## Addendum #1

**Brewer Armory Telecom (IT) Room Repair Project - Project No: 23SR19-310-D4, Bid Number #23-029**

Directorate of Facilities Engineering

28 August 2023

SHEET ID:  
**M-101**  
SHEET: 13 of 18

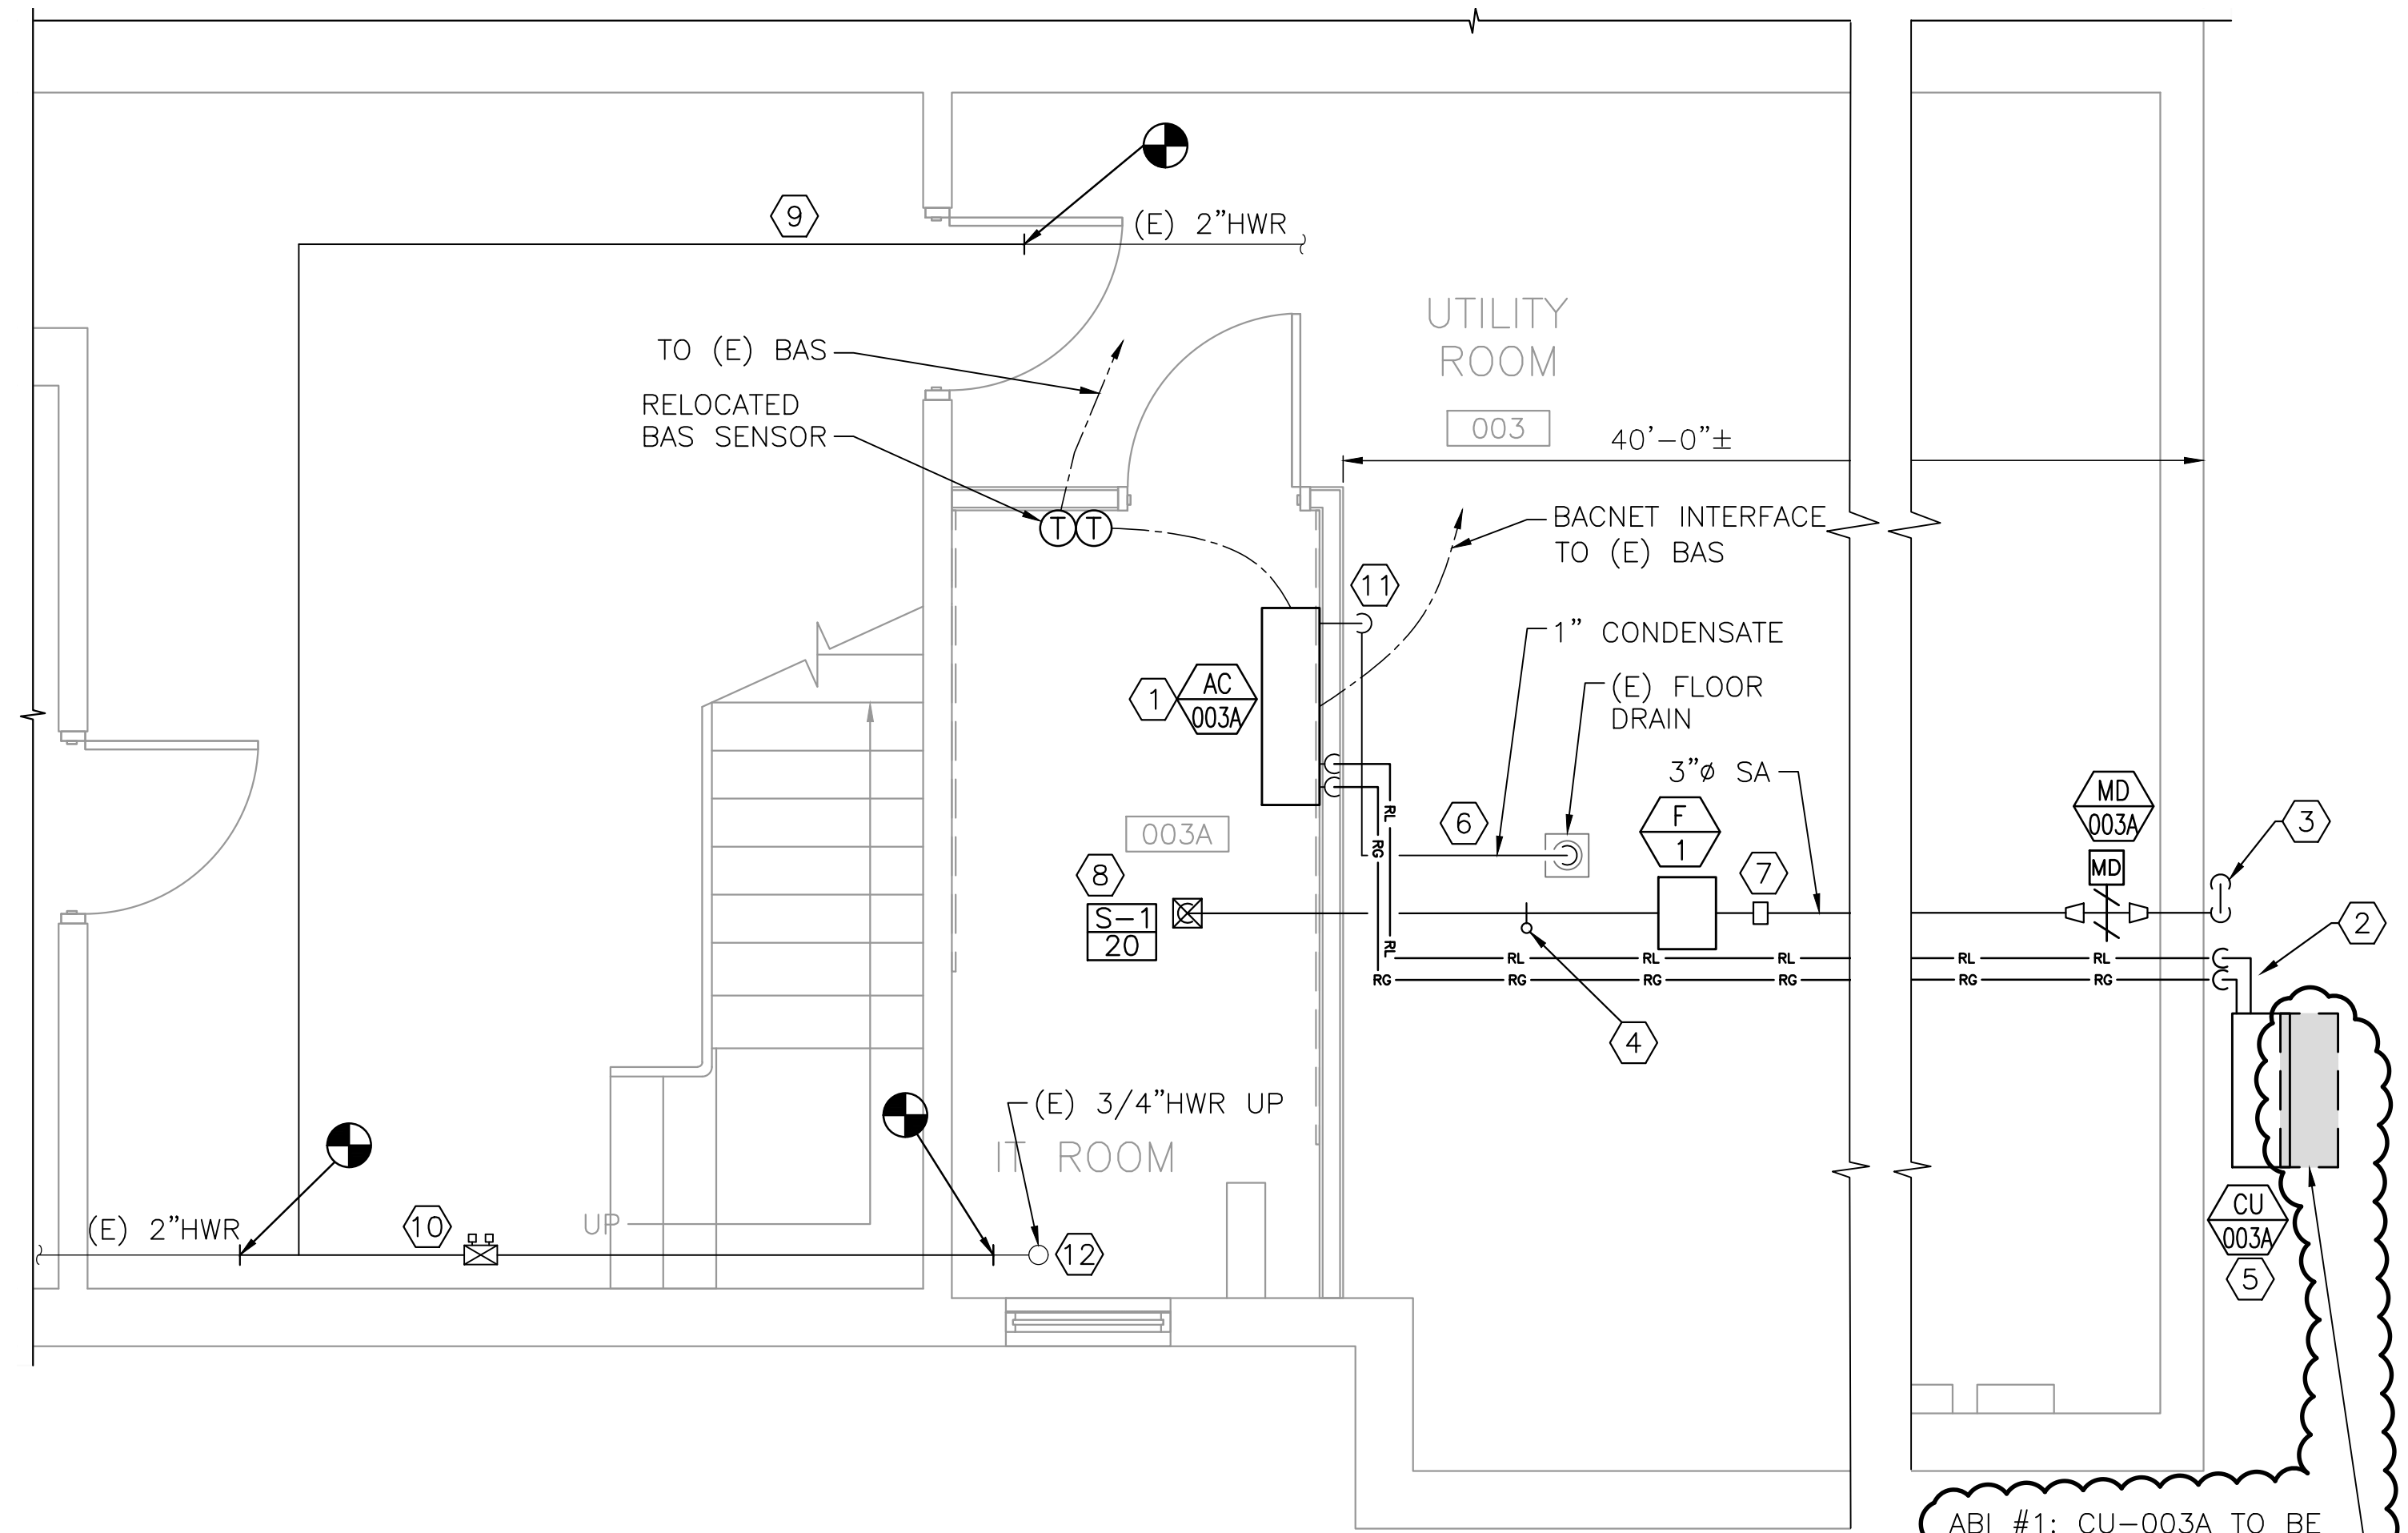
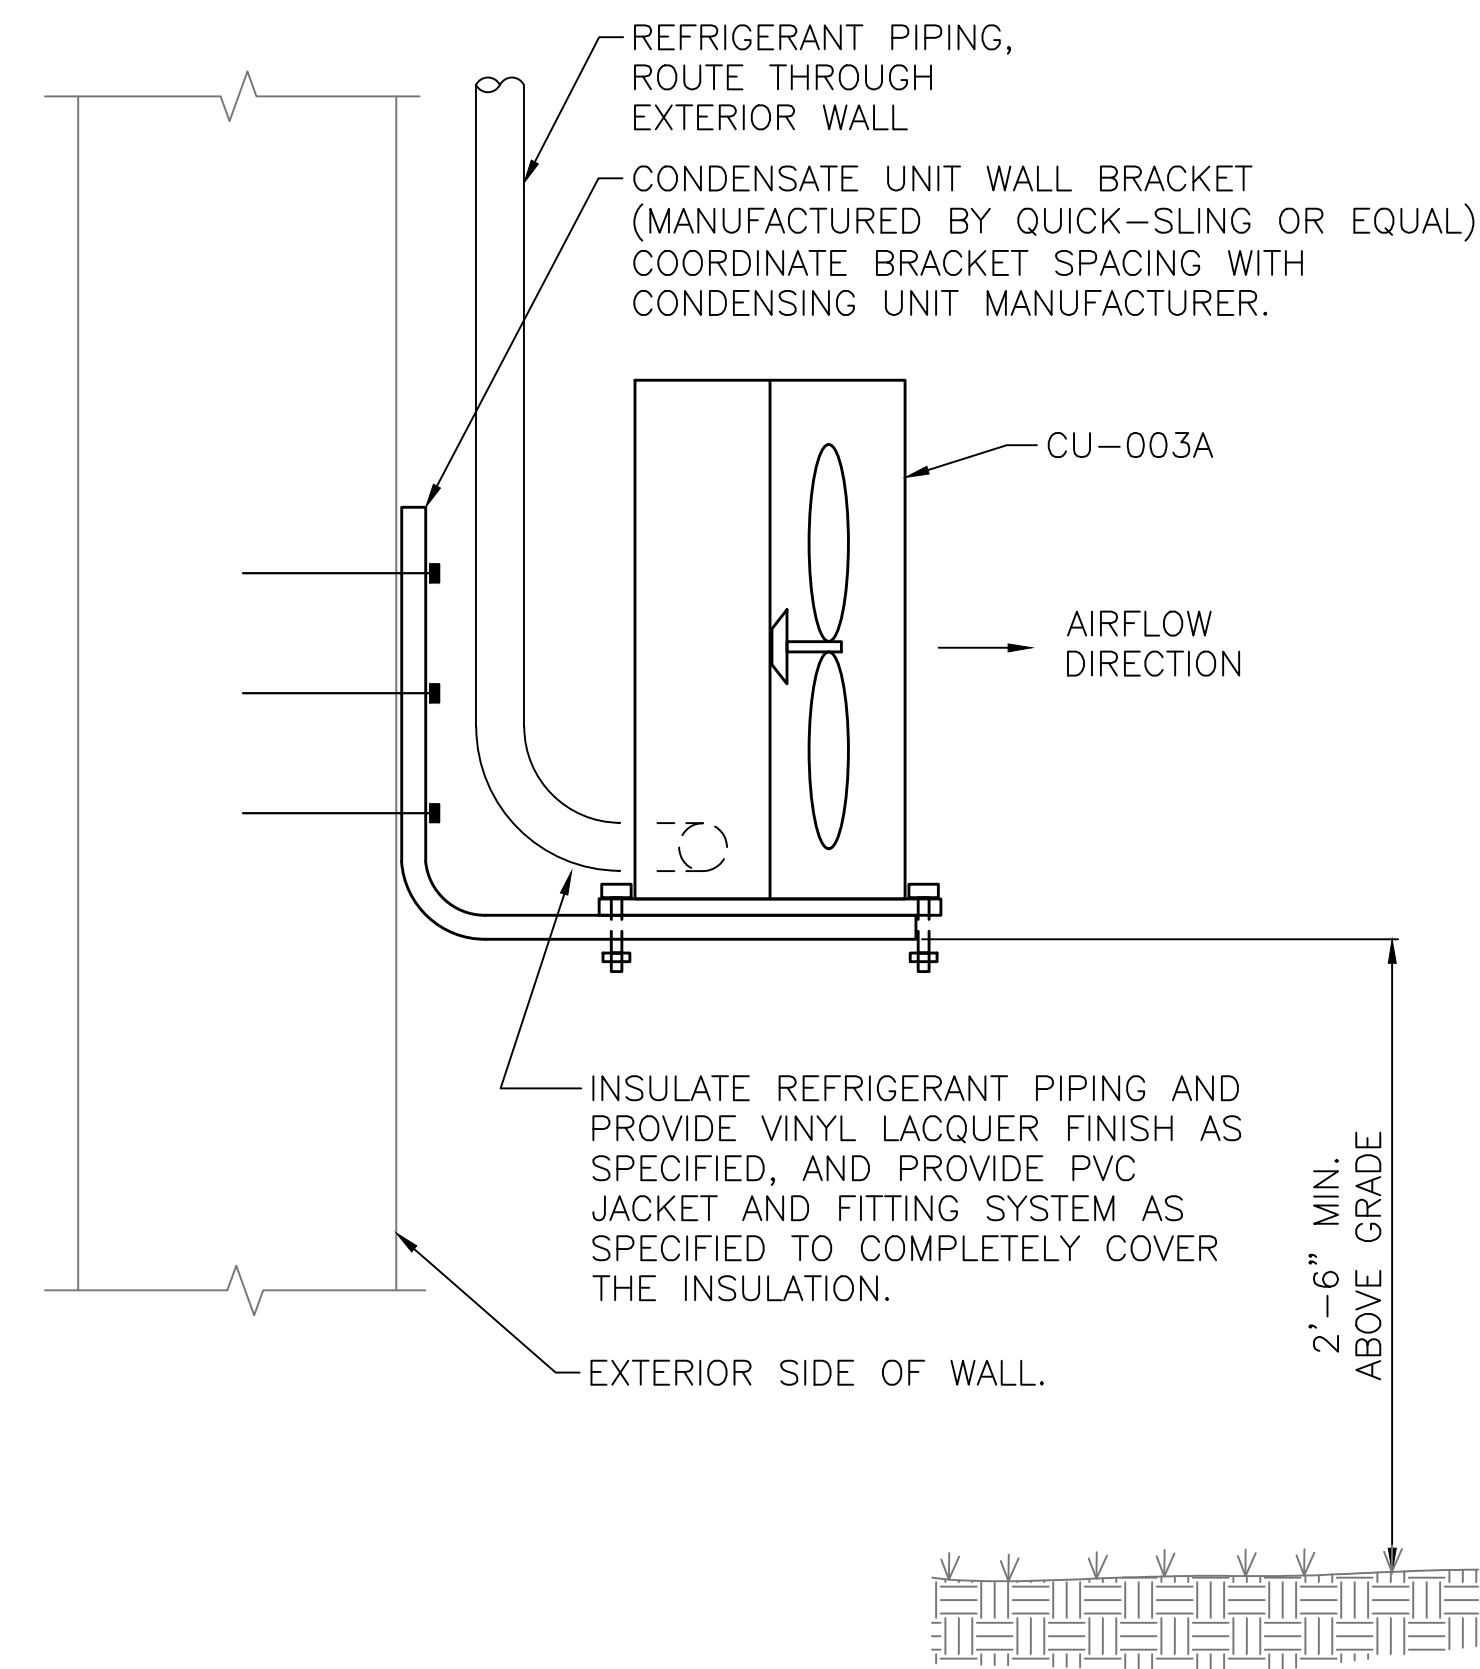
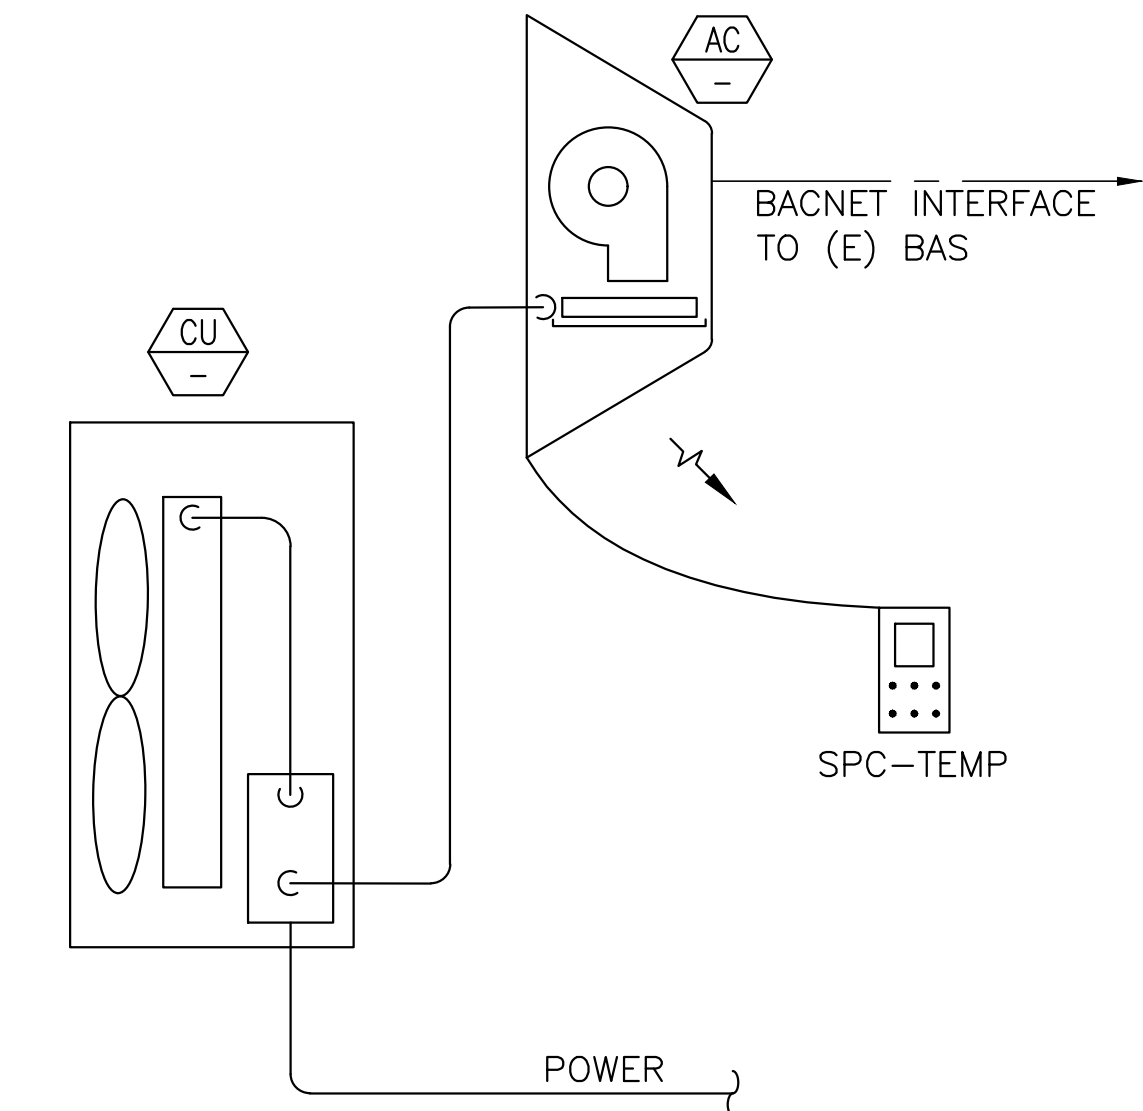
1. **Remove** Sheets C-101, M101 and M-501 and **Insert** attached Sheets C-101, M101 and M-501. All changes regard either the attachment of the mini-split condensate unit to the facility or its placement on a concrete pad immediately adjacent to the facility (ABI#1)

A: Many options were discussed and MEARNG prefers a pipe to the floor drain with a protective cover over it as specified in the plans. Note 6 on sheet M-101. Changes can be proposed after the bid is awarded.

A: TBD. MEARNG has reached out to the Historical Society for a determination. Design drawings have been revised to show painting of the unit to match the brick façade if the unit is allowed to be mounted on the wall.

- 4 IRIS DAMPER, BALANCED TO 20 CFM.
- 5 MOUNT CONDENSING UNIT ON EXTERIOR WALL WITH BRACKETS. BOTTOM OF UNIT MUST BE AT LEAST 2'-6" ABOVE GRADE. BRACKETS TO BE PAINTED TO MATCH FACADE COLOR. CONSULT WITH OWNER TO DETERMINE COLOR AND PRODUCT.

- 6 GRAVITY DRAIN AC CONDENSATE. ROUTE ALONG FLOOR TO EXISTING DRAIN, WITH ELBOW DOWN THROUGH HOLE IN GRATE; PROVIDE HOLE AS NECESSARY. PROVIDE PIPE RAMP TO PREVENT TRIP HAZARD; FORMED OF 14-GAUGE MIN GALVANIZED STEEL WITH LOW-SLOPED SIDES AND REMOVABLE HEX-HEAD FLOOR ANCHORS.

ABI #1: CU-003A TO BE MOUNTED ON SUPPORT FRAME AND SET ON CONCRETE PAD. SEE A-101 FOR PAD LOCATION.
